**NEW YORK STATE THRUWAY AUTHORITY
DEPARTMENT OF ENGINEERING**

**AMENDMENT NO. 1
TO**

**CONTRACT TAB 25-31
D214980
1R MILL AND INLAY, SAFETY IMPROVMENTS AND MISCELLANEOUS
WORK ON I-90 FROM MILEPOST 416.90 TO 419.40
IN THE BUFFALO DIVISION
OF THE NEW YORK STATE THRUWAY
IN ERIE COUNTY**

WEST (RIGHT) CULVERT WALL
SCALE: N.T.S.

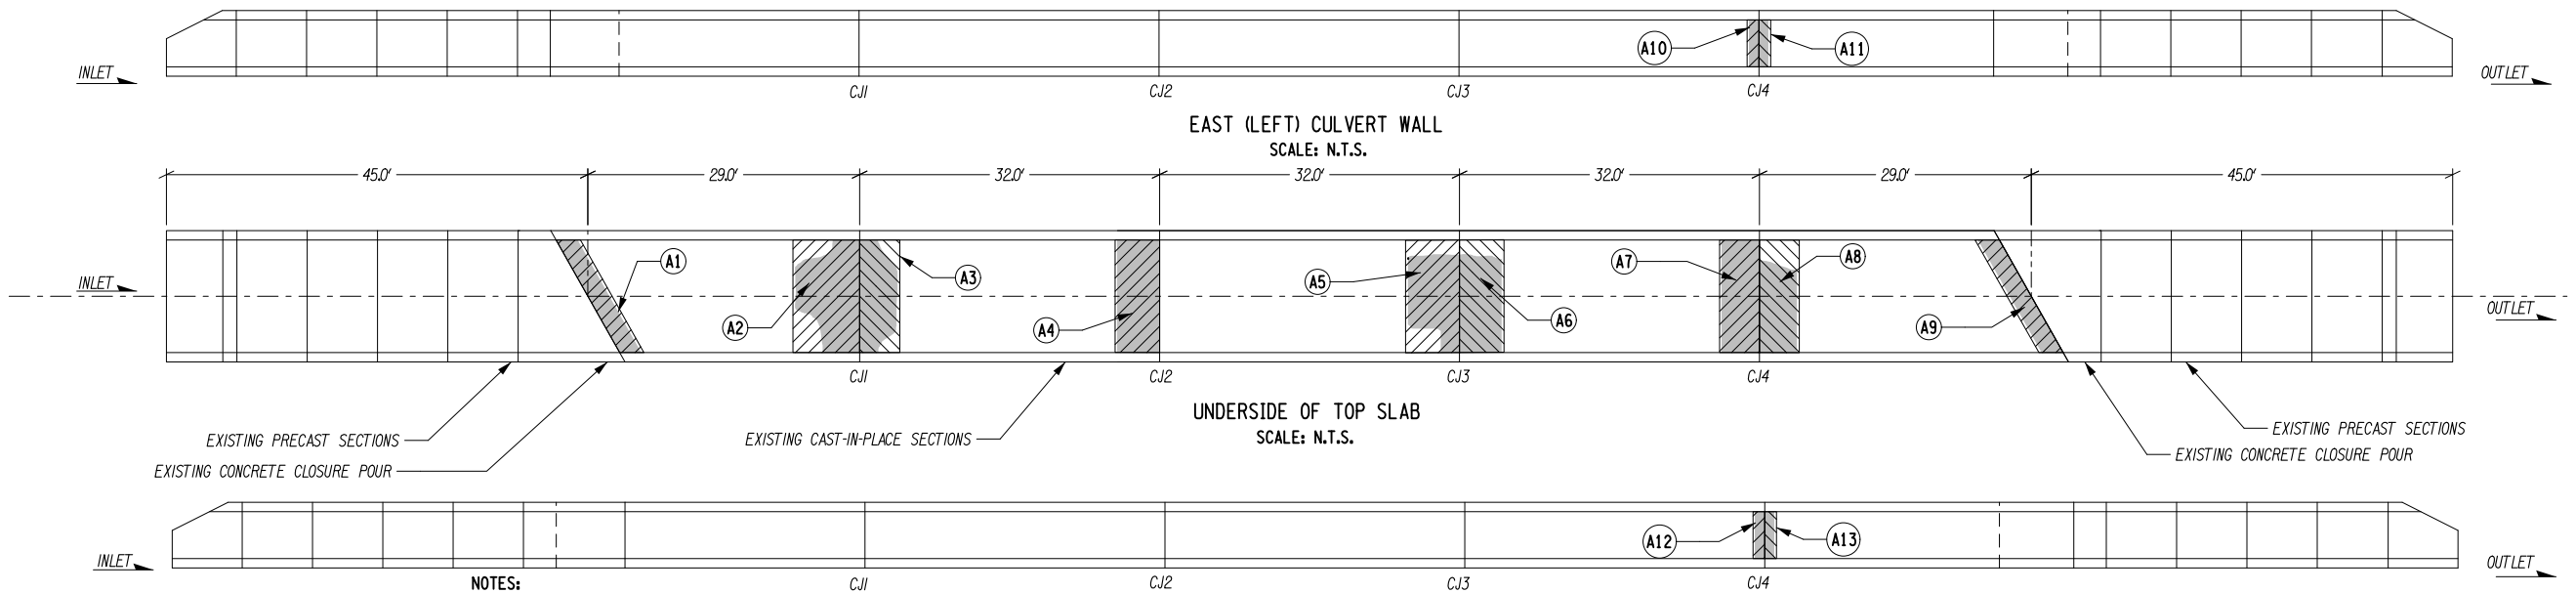
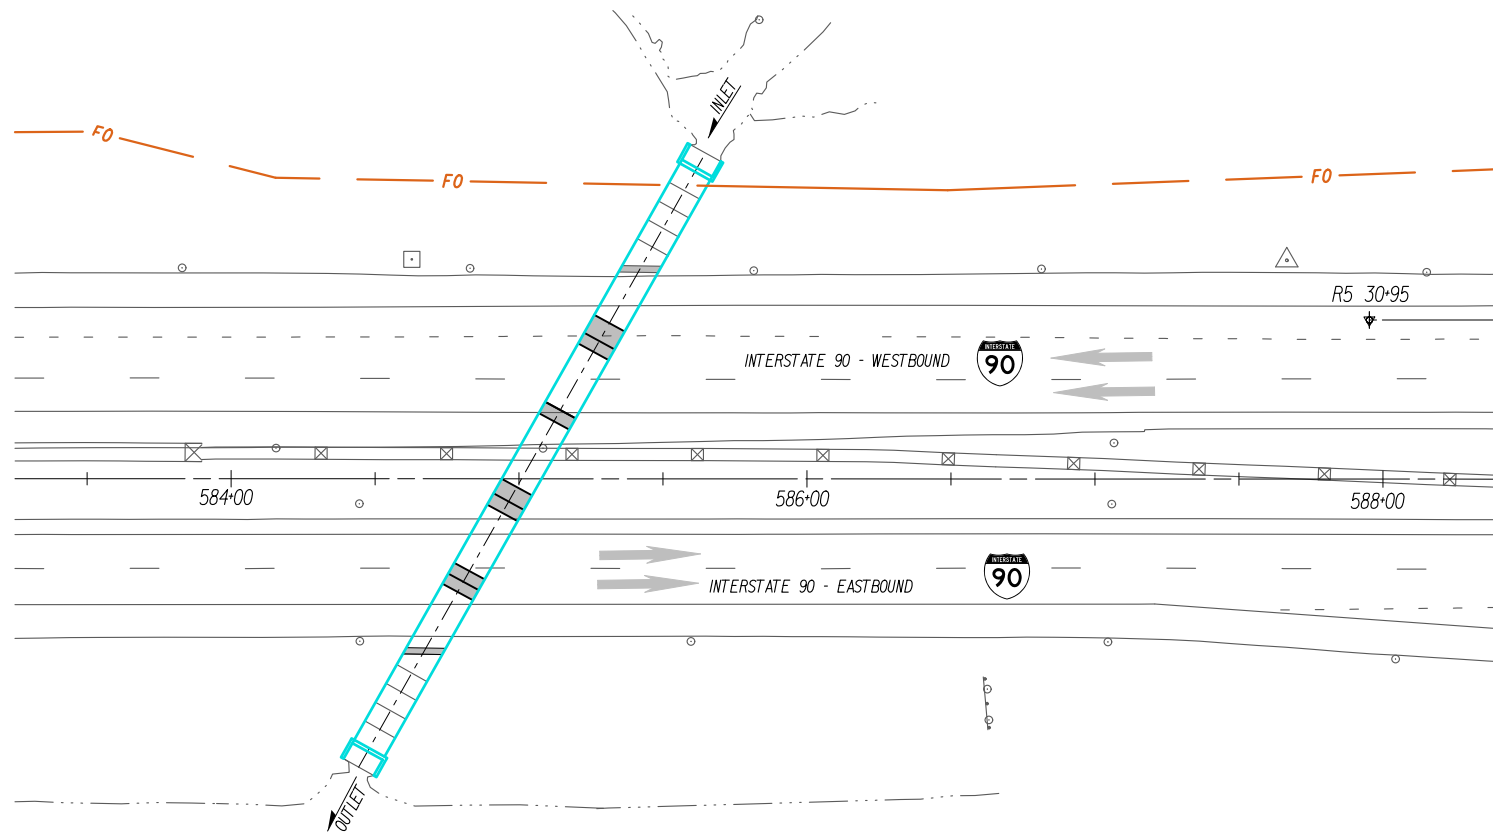
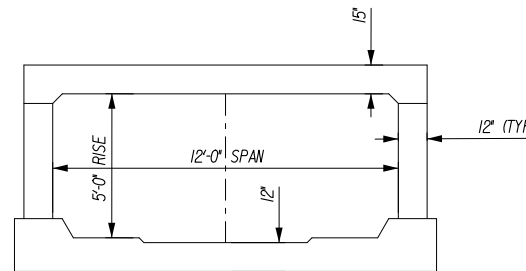
1. **DELETE** Drawing Number CUL-2, Sheet 56 of 58, and **SUBSTITUTE** with the attached Drawing Number CUL-2, Sheet 56-A1 of 58. Note 2 has been revised and the plan view now depicts the repair limits.
